PROJECT: MF-HT 800MHz Building RF Enhancement

Contract No: MF-100.511 WO#21

| PACKAGE | SUBMITTAL | DWG. # | REV. | COPIES | DATE | DESCRIPTION | STATUS |
|---------|-----------|--------|------|--------|----------|-------------|--------|
| 16785 | 16785-052 | | R000 | 4 | 7/1/2015 | Canam BDA | AAN |

| ITEM | PACKAGE | SUBMITTAL | DRAWING | REV. | ITEM NO. | COPIES | DATE | DESCRIPTION | STATUS |
|------|---------|-----------|---------|------|----------|--------|-----------|-------------|--------|
| | 1678 | 052 | | 0 | 1 | 7 | 6/25/2015 | CANAM BDA | AAN |

MARK-IV DIGITAL Class-A Narrowband and Signal Booster Public Safety 800 MHz Analog and Digital P25, TETRA & TETRAPOL

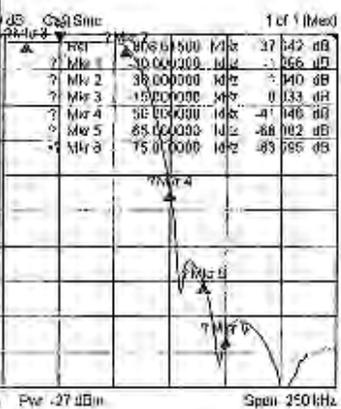
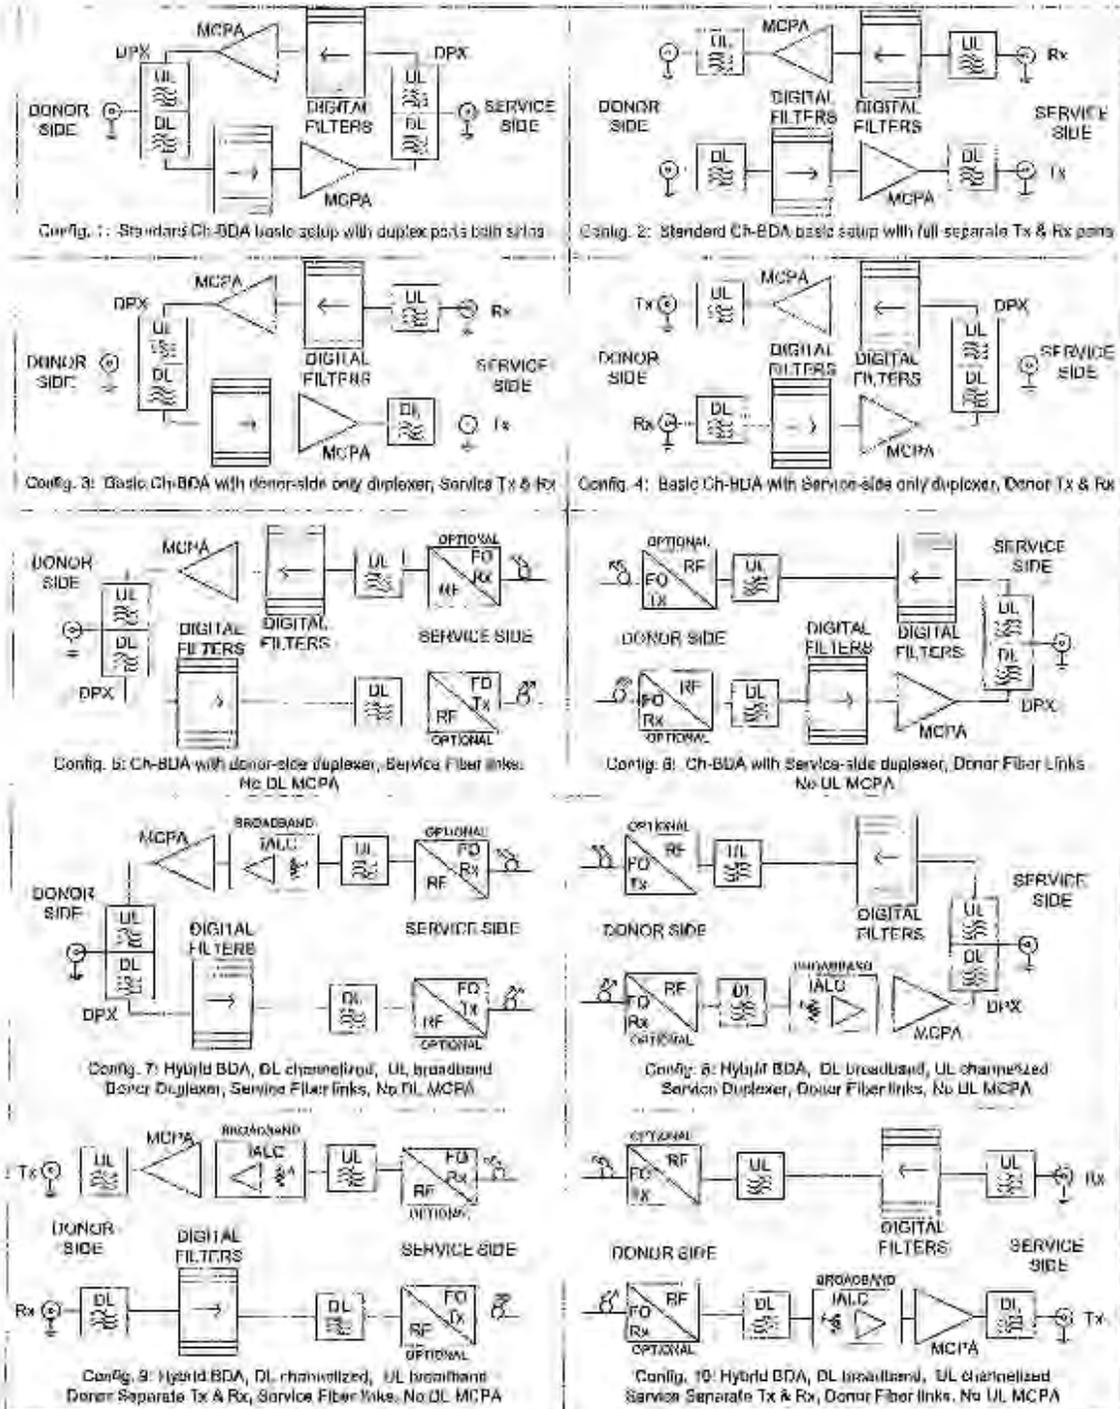
Remarks: NOTE: BDA PART # M4D-10C806-3R-K3

Note - BDA Part # M4D-100-806-3R-K3
